LARK RAVINE

VARIANCE REQUEST

April 16, 2025

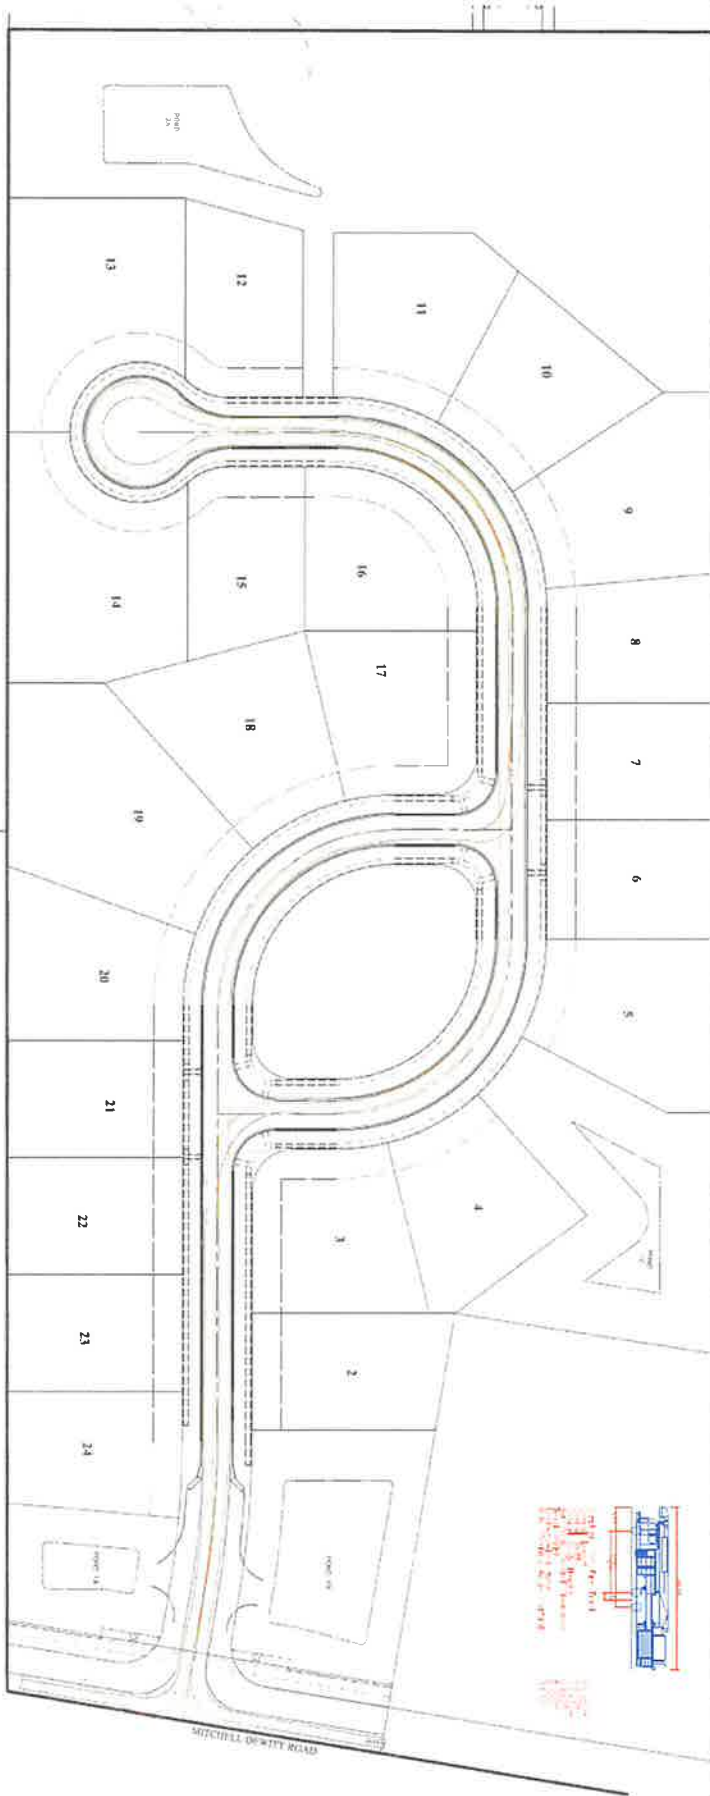
Romanelli and Hughes, the Applicant and Developer, is requesting a variance to remove the Fox Field Path connection to Lark Ravine and to allow a permanent dead end street. See Variance Exhibit attached for a graphic depiction of the issue.

1. *The existence of exceptional topographic or other physical conditions,*
There is a significant amount of grade change at the end of Fox Field Path that will require a large culvert or bridge.
2. *Strict application of these regulations would result in extraordinary and unnecessary hardship,*
The cost to install a culvert or bridge will result in an extraordinary financial hardship for the Developer. And, according to correspondence between the Developer and the Fire Department, the connection is unnecessary.
3. *The purpose and intent of these regulations can be equally or better served.*
The Developer believes that the purpose and intent of the regulations, in regards to connectivity, will not be affected if the variance is approved.

While the best option for community safety is to have a secondary access point, we understand the limitations. We can provide conditional approval to eliminate the secondary access as long as there is a secondary water line established as presented. Please confirm that the water will still be connected on Mitchell Dewitt Rd. The other conditions as we discussed were the installation of a dry hydrant, maintain street widths of 26', the cul-de-sac dimensions of no less than 96', and the auto-turn which has been presented. All hydrants shall be installed per the City of Marysville specifications and shall be no more than 350' apart.
